LETTER OF TRANSMITTAL

REFERENCE: DCI2019-00019 - Amavida RPD (f/k/a Avida RPD/CPD) JOB NO: 1620QG

Table with 2 columns: COPIES, DESCRIPTION. Row 1: 3, Revised Master Concept Plan (11"x17" & 24"x36")

MASTER CONCEPT PLAN AMAVIDA RPD, F.K.A. AVIDA LEE COUNTY, FLORIDA							
DATE	PROJECT	DRAWING	DESIGN	DRAWN	CHECKED	SCALE	SHEET
7/26/2019	1620QG	MCP	SEH	JLS	SEH	1"=200'	1

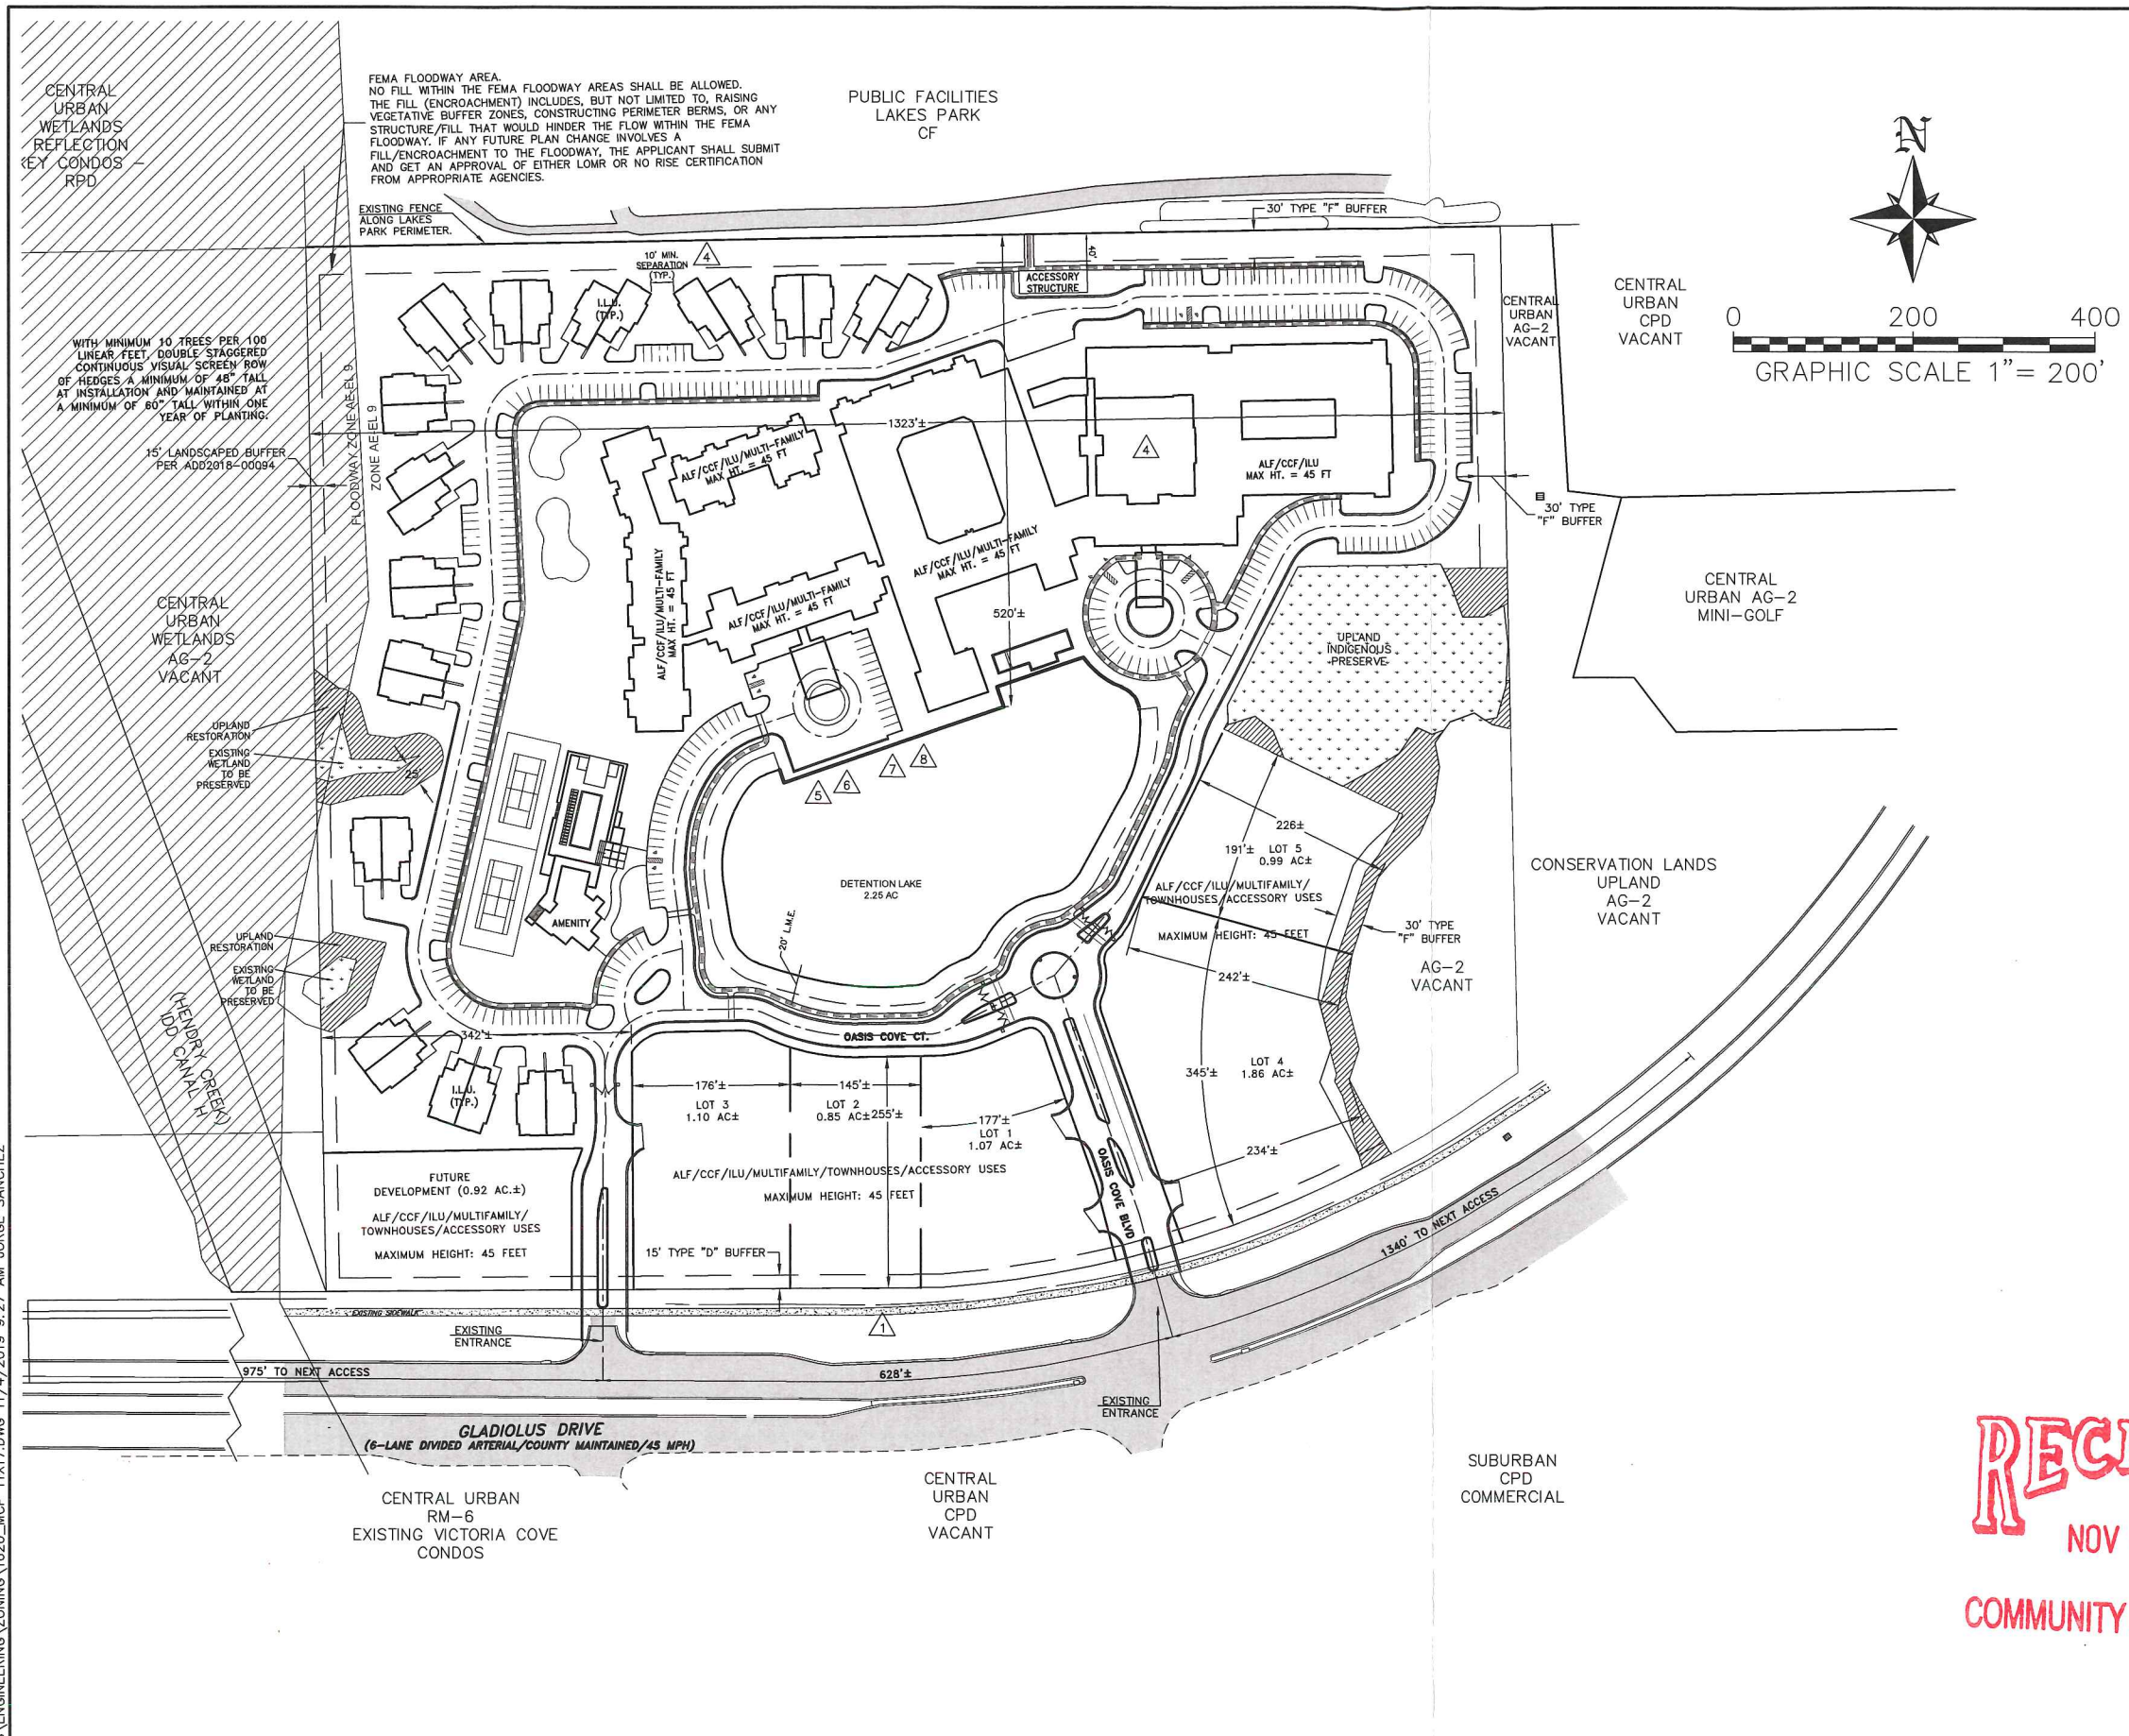
The attached MCP has been updated to reflect 40% open space pursuant to emails with Beth Workman. Please do not hesitate to contact me if you have any questions or need anything. Thank you and take care,

NO.	DATE	REVISION DESCRIPTION	BY
2	11/4/2019	UPDATE OPEN SPACE TABLE	SEH
1	10/17/2019	1ST SUFFICIENCY RESPONSE	SEH

**REQUIRED OPEN SPACE:**  
 RPD: 40% 32.54 @ 40% = 13.02 AC.  
 TOTAL REQUIRED: 13.02 AC MINIMUM

**UPLAND OPEN SPACE CREDITS:**  
 1.19 AC UPLAND AREA x 1.25 CREDIT FOR MORE THAN 1 AC [LDC 10.415(b)(3)a] + 10% CREDIT FOR COMBINING WITH OFFSITE PUBLIC PRESERVE [LDC 40-415 (b)(3)b.2.] (1.19 x 1.35) = 1.60 AC. TOTAL UPLAND WITH OPEN SPACE CREDITS WETLAND = 0.10 AC.  
 TOTAL INDIGENOUS = 1.70 AC.  
 LAKE = 2.25 AC.  
 BUFFERS/LAKE MAINTENANCE EASEMENT/FEMA FLOODWAY = 2.06± AC.  
 RESTORATION AREAS = 0.74 AC.  
 ADDITIONAL OPEN SPACE = 6.27 AC.  
 TOTAL OPEN SPACE PROVIDED = MINIMUM 13.02 AC/CR
